# PLANNING COMMISSION STAFF REPORT

## LEGACY ESTATES SUBDIVISION – DESIGN PLAN

## Re: Legacy Estates Subdivision – Design Plan Review

**Overall Site Plan**  
 for  
**Legacy Estates**  
 Miami Township, Clermont County, Ohio  
 Howell's Military Survey No. 1776  
 Parcel No. 17-25-20E-016

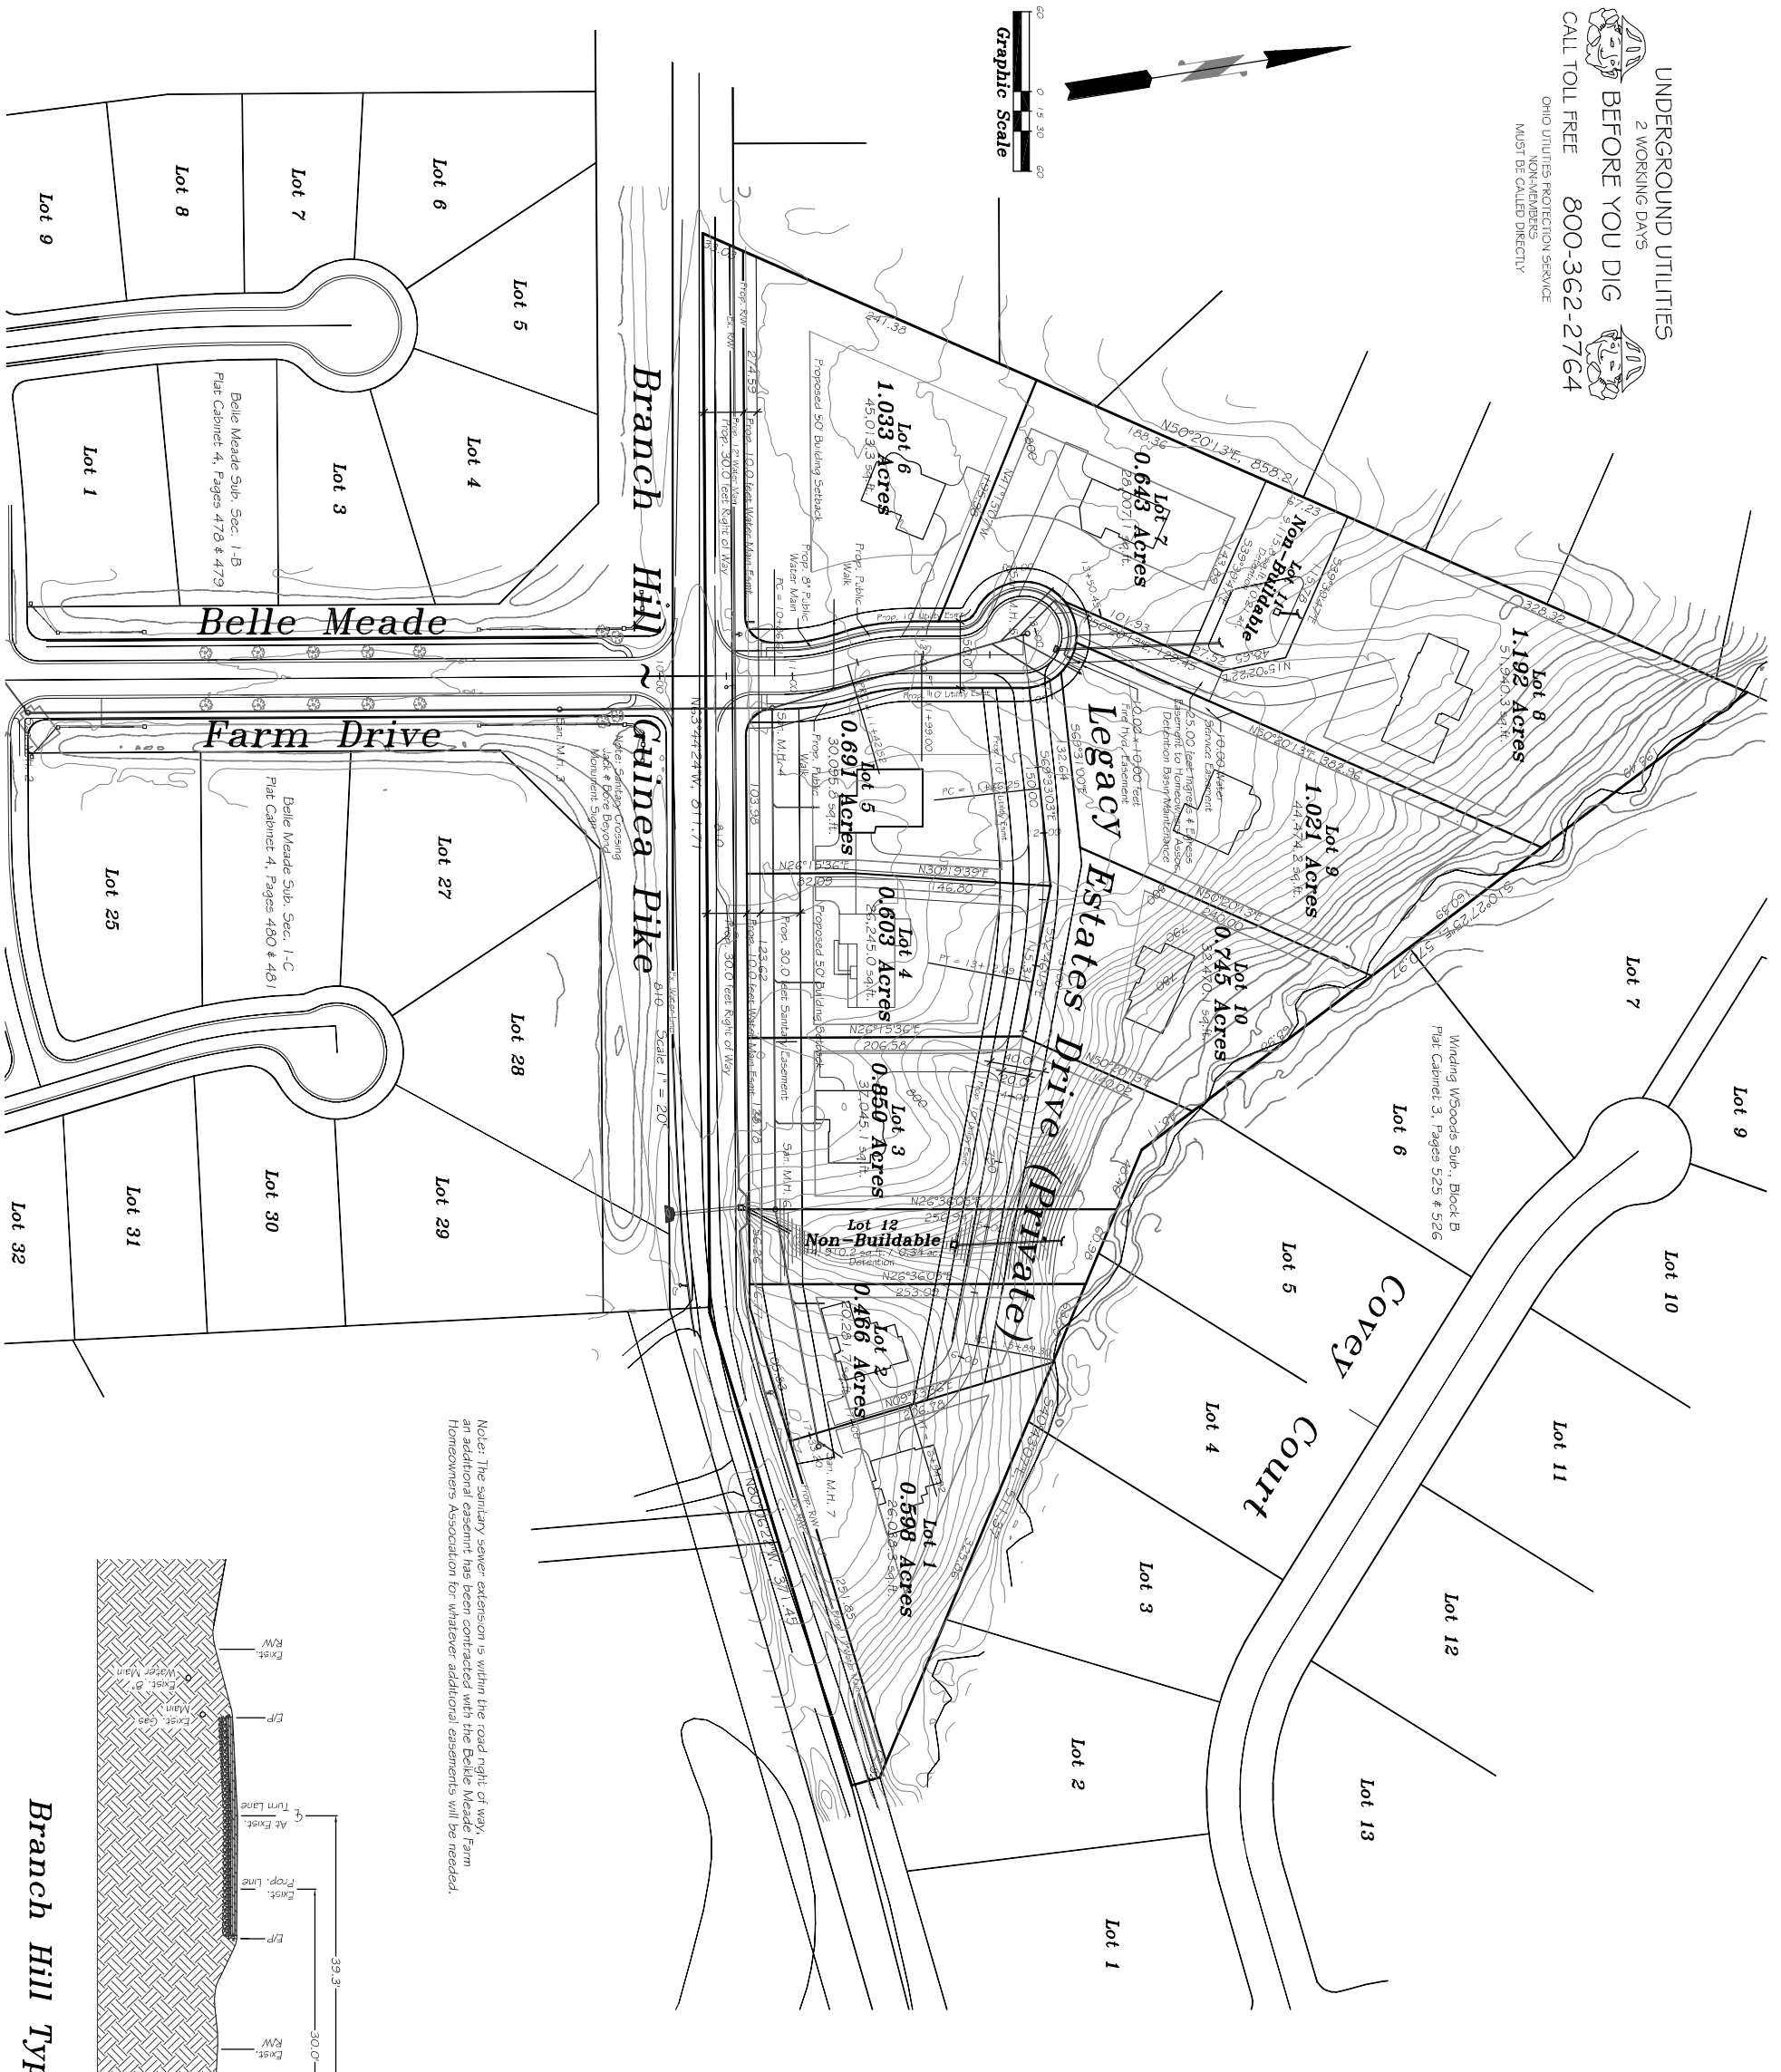
6. Include land in “open space” listed in “Area Breakdowns” on cover sheet.
7. There is a typo in the adjacent subdivision located on sheet 2 of the plan set: it states “Winding WSoods” Sub.

**Roadways - Plan & Profile**  
for  
**Legacy Estates**  
Miami Township, Clermont County, Ohio  
Howell's Military Survey No. 1776  
Parcel No. 17-25-20E-016

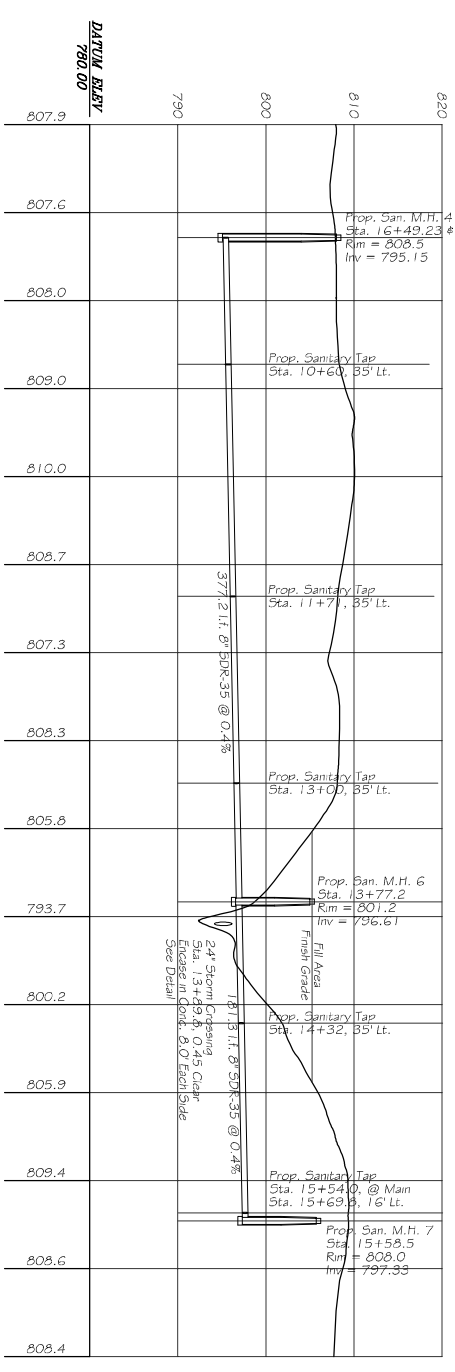
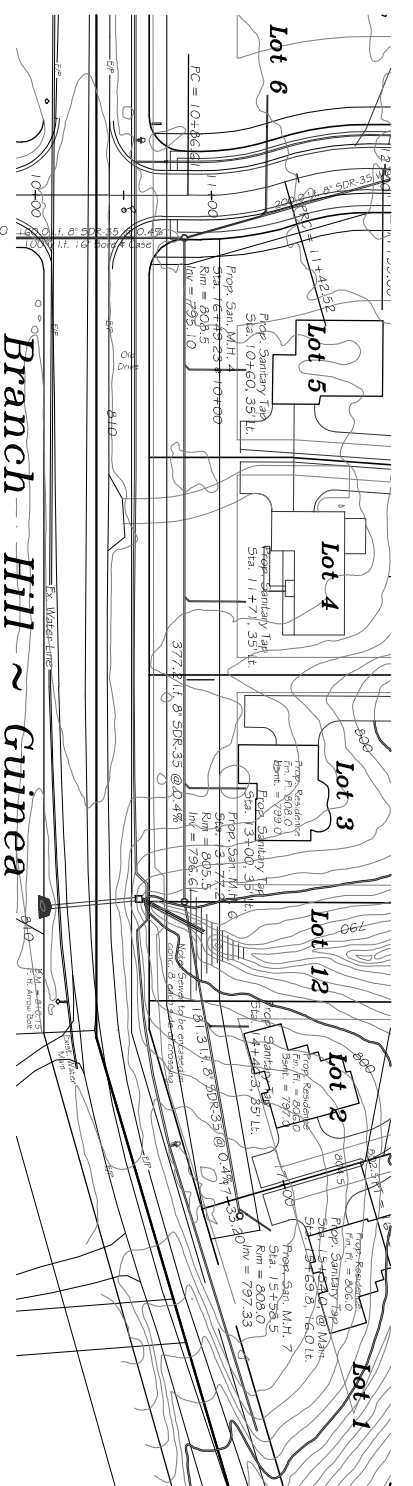
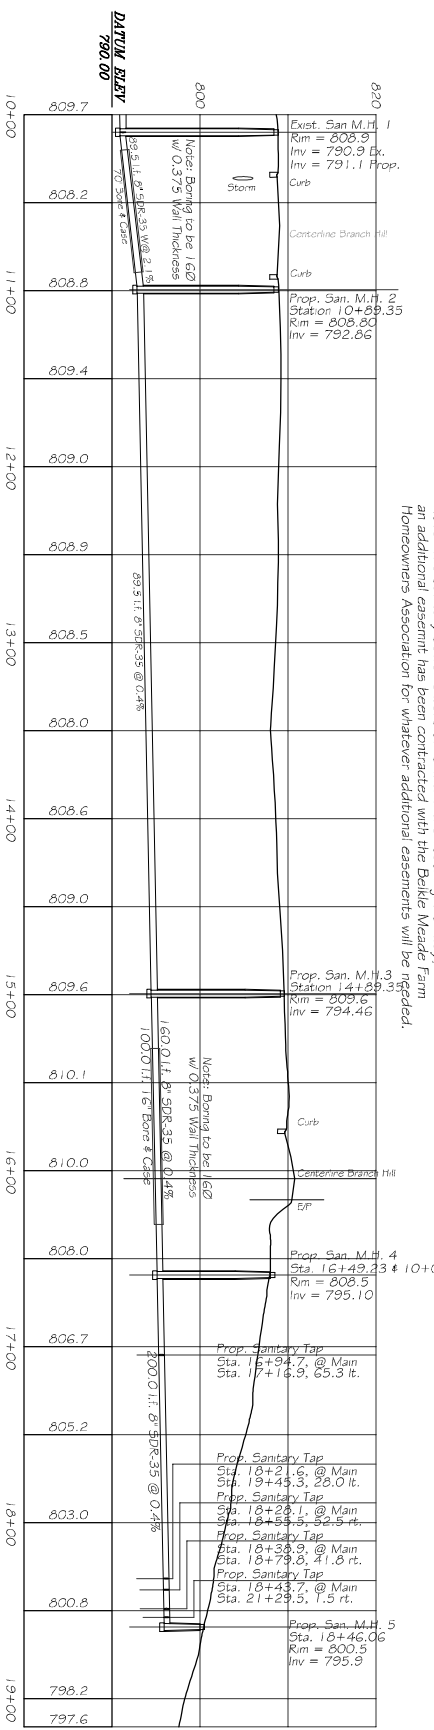
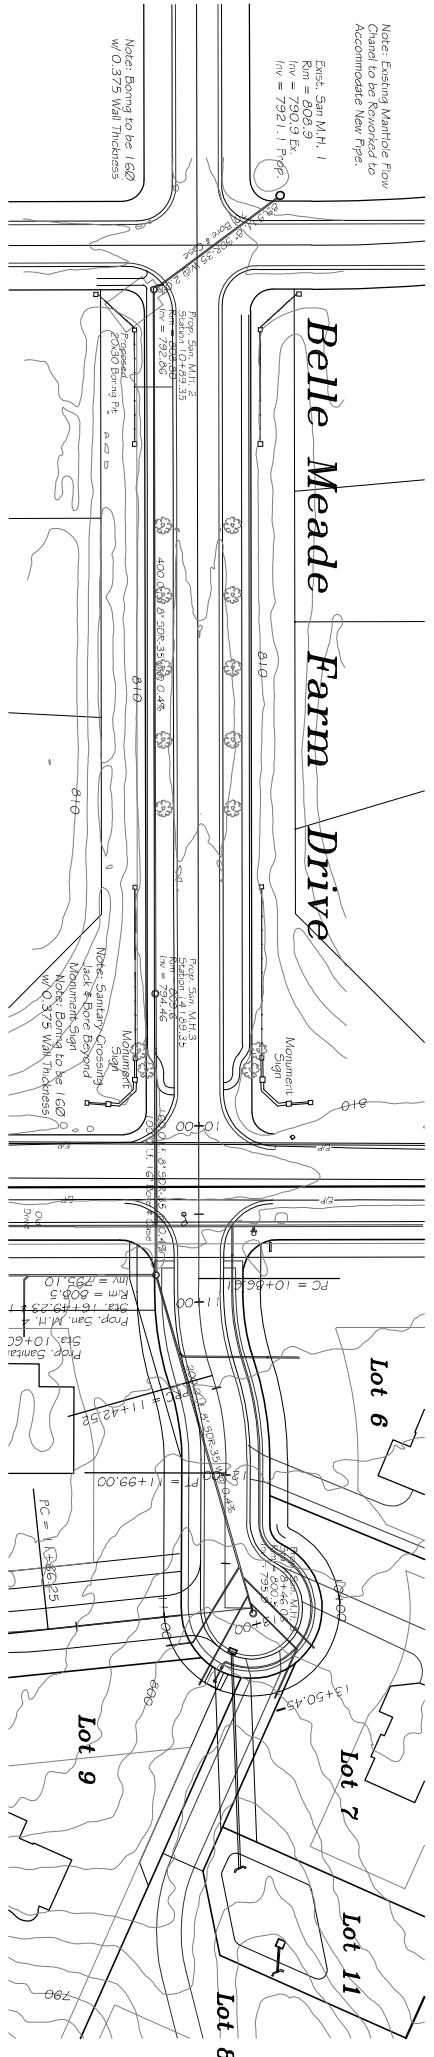
| 13 | 2/3 of 4 | Centerline Curve Data needs to be provided for the Two (2) curves located between Stations 10+86.61 and 11+99.00. The minimum centerline curve radius is 200’.  |
| 14 | 3 of 4   | The Label for the Legacy Estates Drive Plan/Profile and Typical Section need to be changed to Private Street.   |
| 15 | 3 of 4   | The Label for the Belle-Meade Farm Drive Typical Section needs to be changed to Local Street - Class 1.   |
| 16 | 3 of 4   | The Belle-Meade Farm Drive Typical Section needs to be adjusted to match the Clermont County Local Street - Class 1 / Aggregate Base Typical Section. The Underdrains need to be added to the detail. Additionally, the Aggregate Base needs to be extended past the proposed concrete curbs. |
